Concurrence Point 2 (Design Options for Detailed Study) Revision

Subject: STIP Number A-0010A, CP2 Revision, US 19/23 (Future I-26) Improvements, Buncombe County, North Carolina

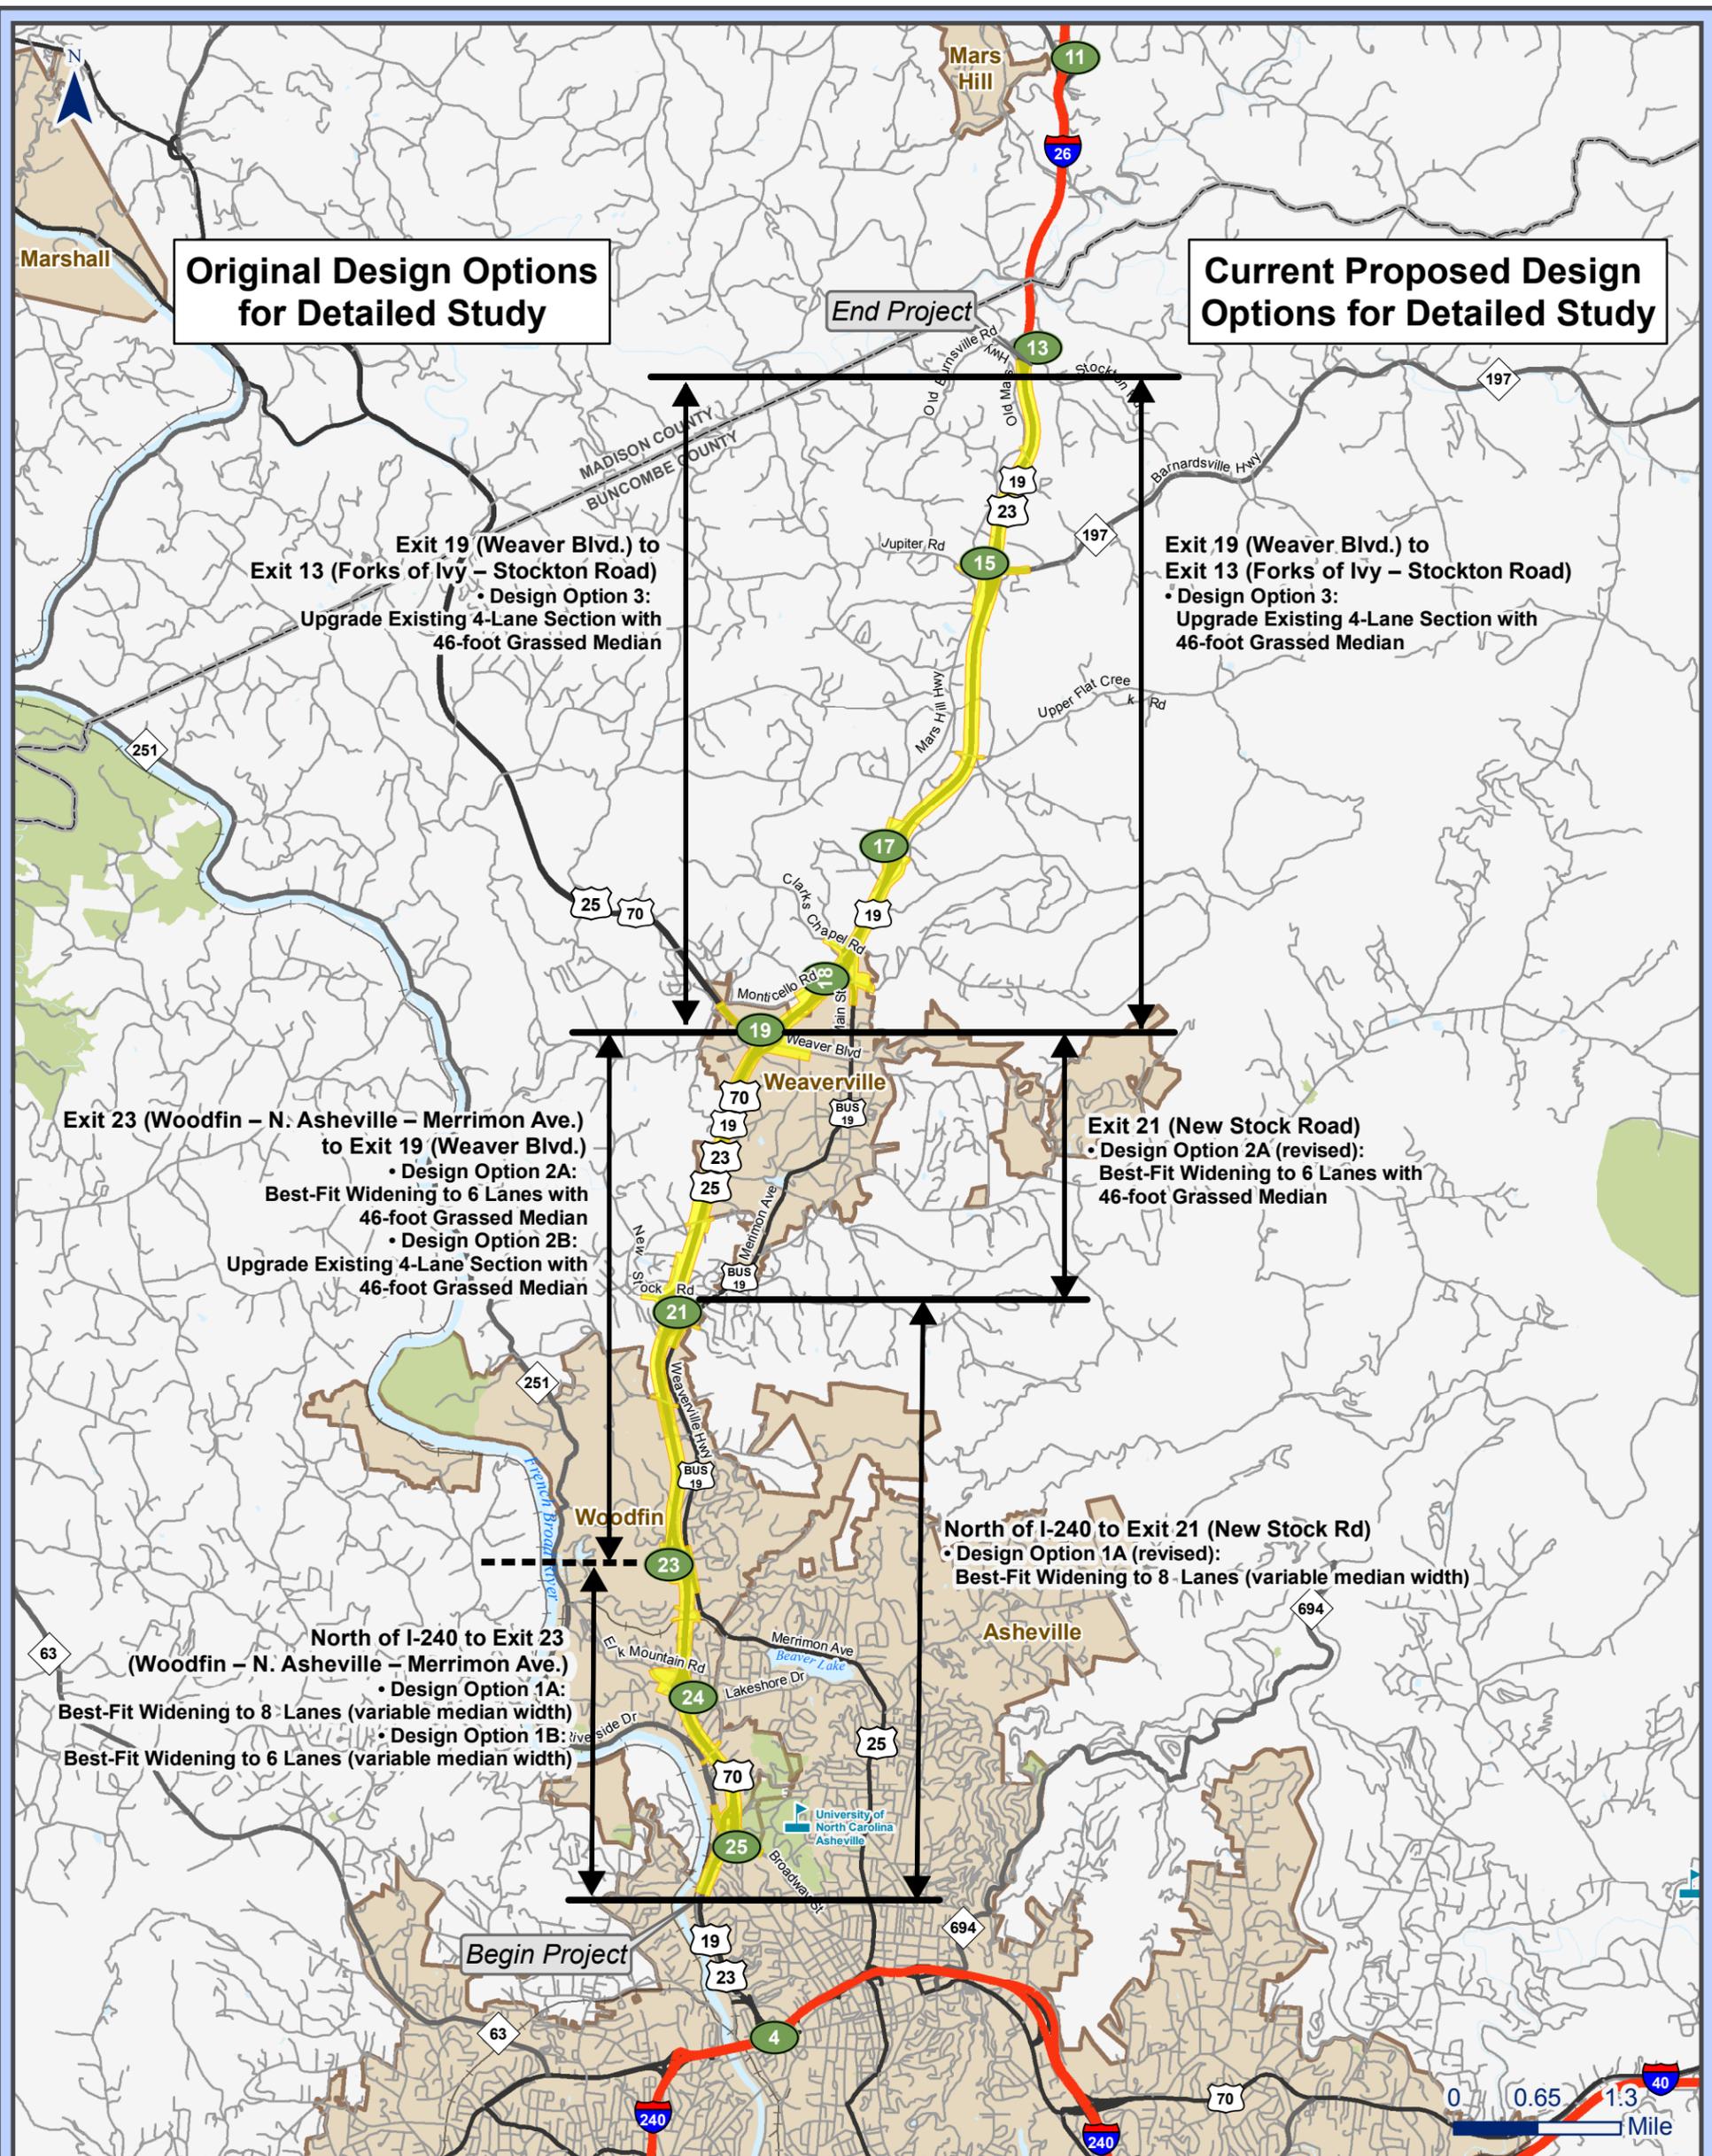
NCDOT is recommending that based on the results of the recent traffic forecast and capacity analysis updates, as well as the best available data at this time, the following design options be carried forward for detailed study and preliminary design:

One design option from north of I-240 to New Stock Road (Exit 21):

- Design Option 1A (revised): Best-Fit Widening to 8 Lanes (variable median width)

One design option from New Stock Road (Exit 21) to Weaver Boulevard (Exit 19):

- Design Option 2A (revised): Best-Fit Widening to 6 Lanes with 46-foot Grassed Median

One design option from Weaver Boulevard (Exit 19) to Stockton Branch Road (Exit 13):

- Design Option 3: Upgrade Existing 4-Lane Section with 46-foot Grassed Median

The revised design options are shown on Figure 1. If additional data becomes available that affects the minimum typical section required to meet the project purpose, NCDOT may revisit the breakpoints between project sections and shift them as needed to meet the project purpose.

Figure 2: Future Year 2040 Freeway Level of Service

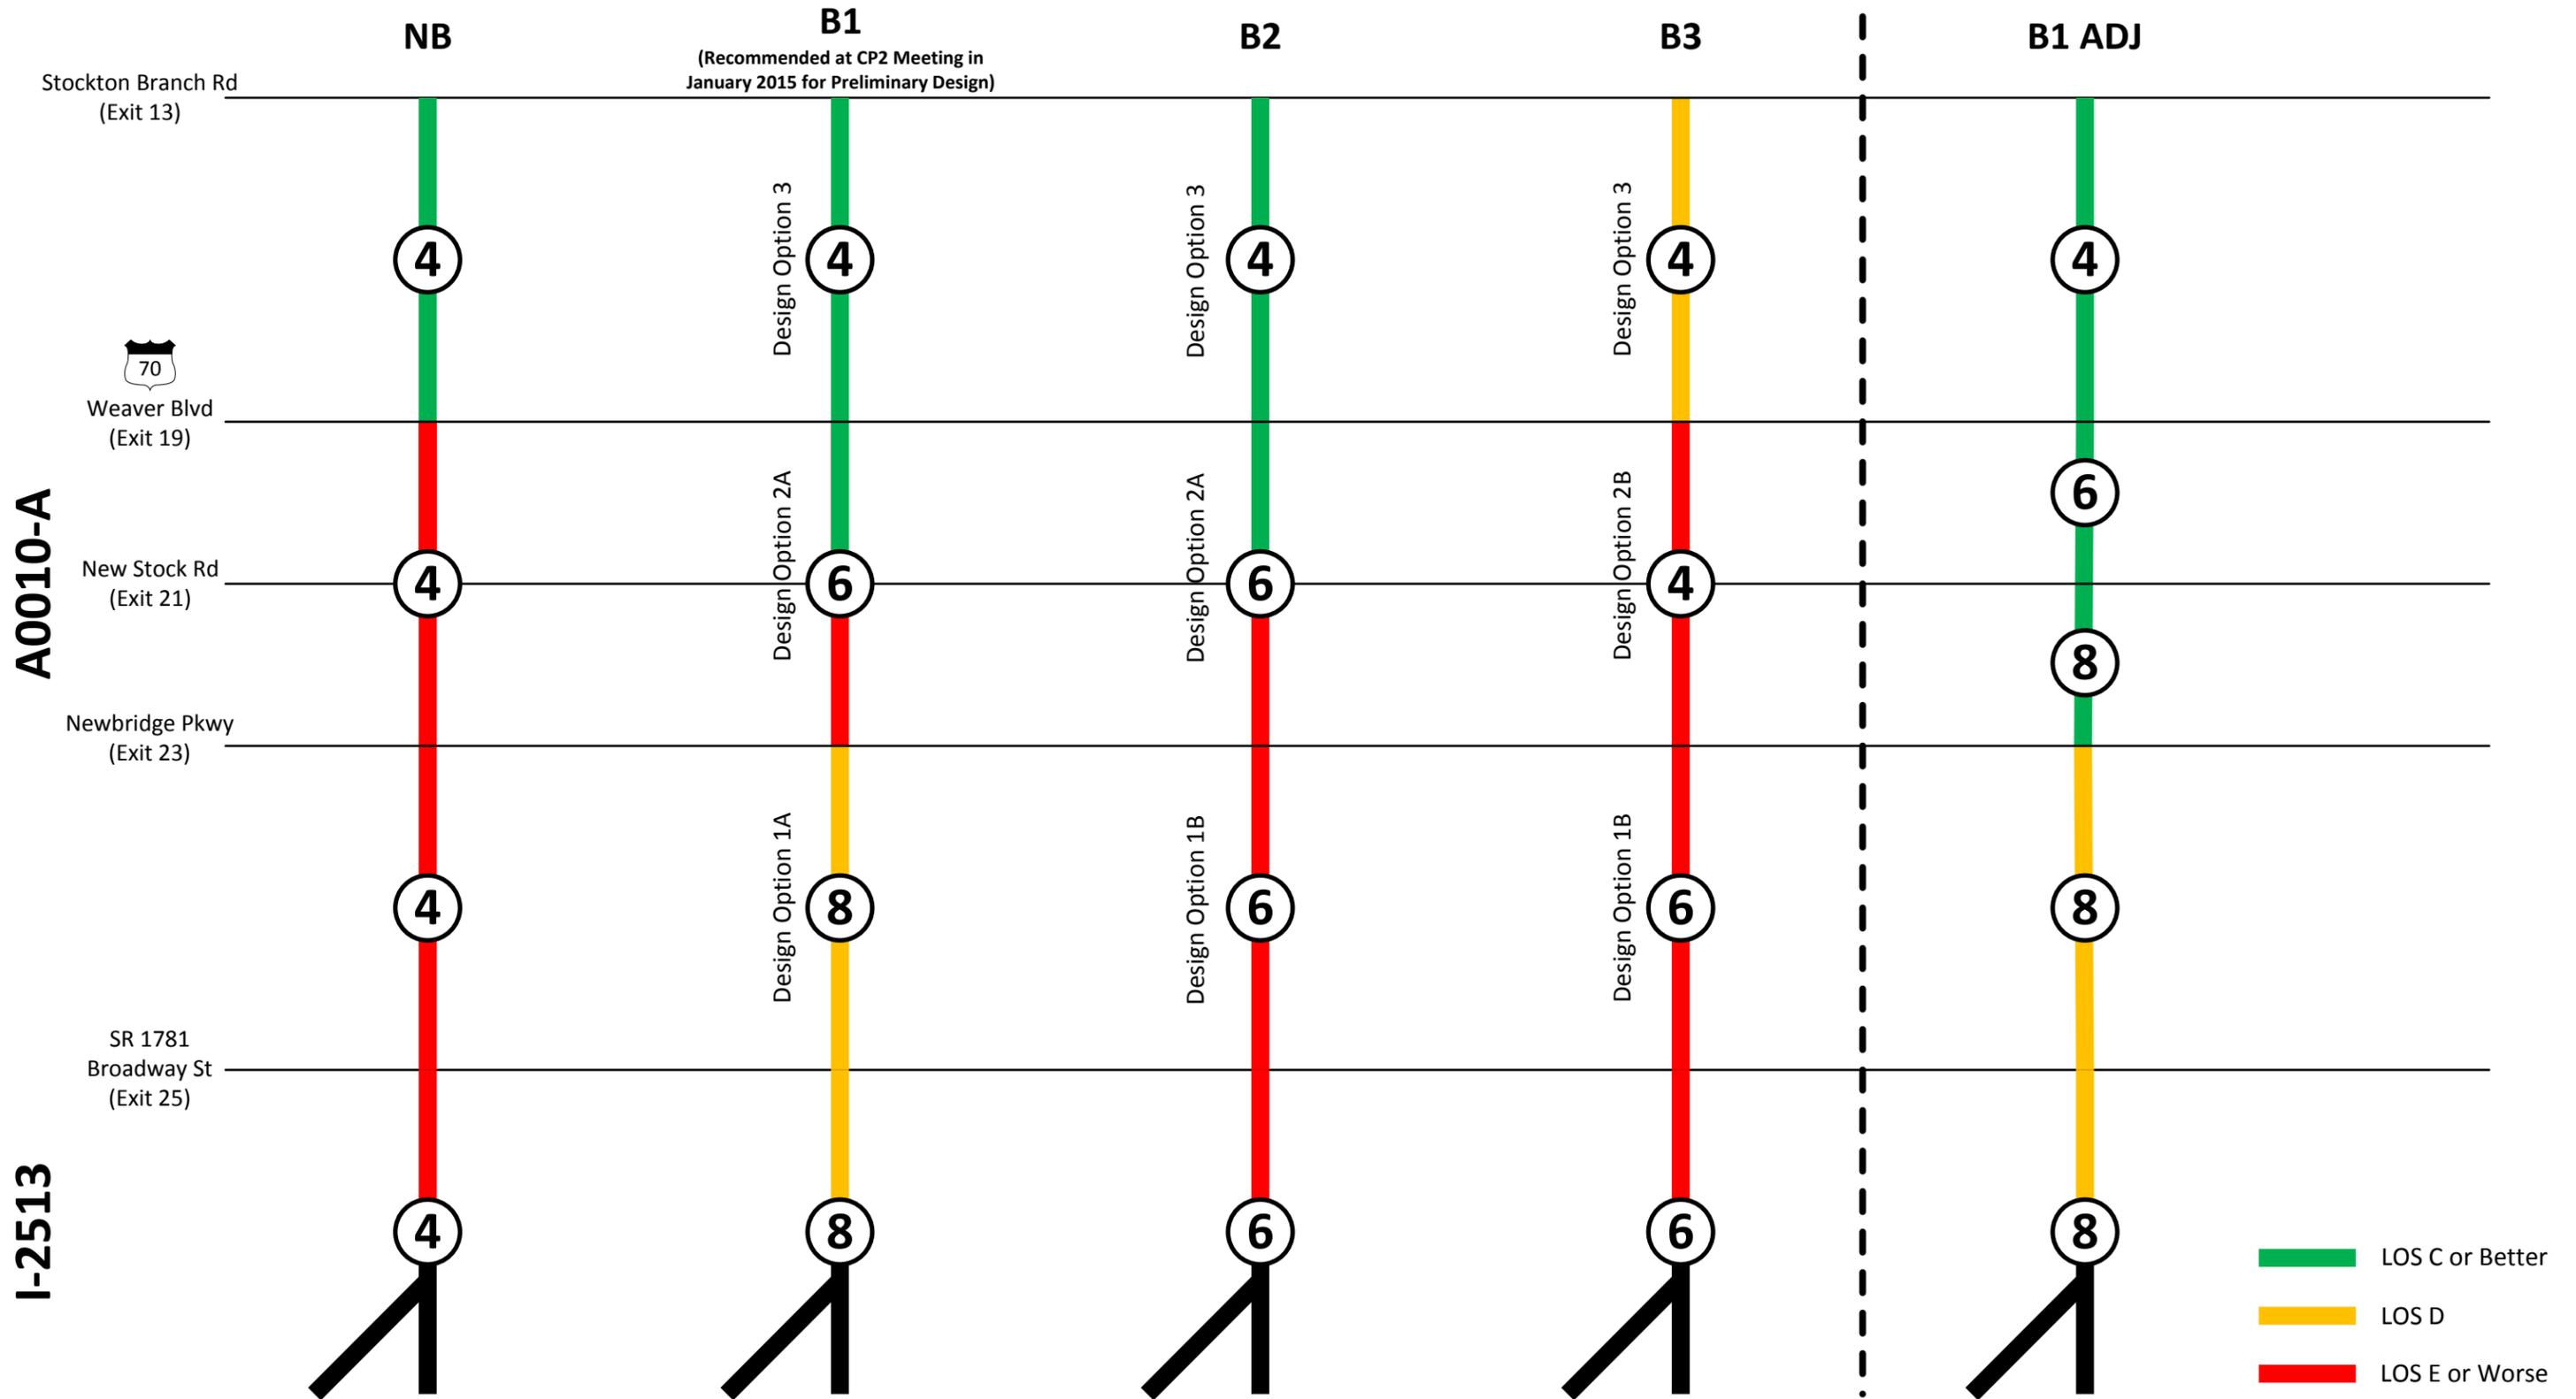
The results of the traffic capacity analysis are shown on **Figure 2**, and indicate none of the current design options, as defined at the 2015 CP2 meeting, would meet the purpose and need of the project. Specifically, the design options do not meet the project purpose of reducing congestion to achieve LOS D for all freeway segments in the design year 2040. As shown in the figure, all forecast scenarios have at least one segment at LOS E or worse in 2040 (indicated in red on the figure).

In order to meet the purpose and need for the project and achieve LOS D on all freeway segments, an additional scenario was evaluated. This scenario is shown on Figure 2 as **B1 ADJ**:

- **B1 ADJ**: 8 lanes from north of I-240 to New Stock Road (Exit 21); 6 lanes from New Stock Road (Exit 21) to Weaver Boulevard (Exit 19); 4 lanes from Weaver Boulevard (Exit 19) to Stockton Branch Road (Exit 13)

As indicated on Figure 2, B1 ADJ would achieve LOS D on all freeway segments through the design year 2040. B1 ADJ is similar to the combination of Design Option 1A and Design Option 2A included in scenario B1, but revises both options by shifting the breakpoint between the 8-lane section and the 6-lane section north from Newbridge Parkway (Exit 23) to New Stock Road (Exit 21).
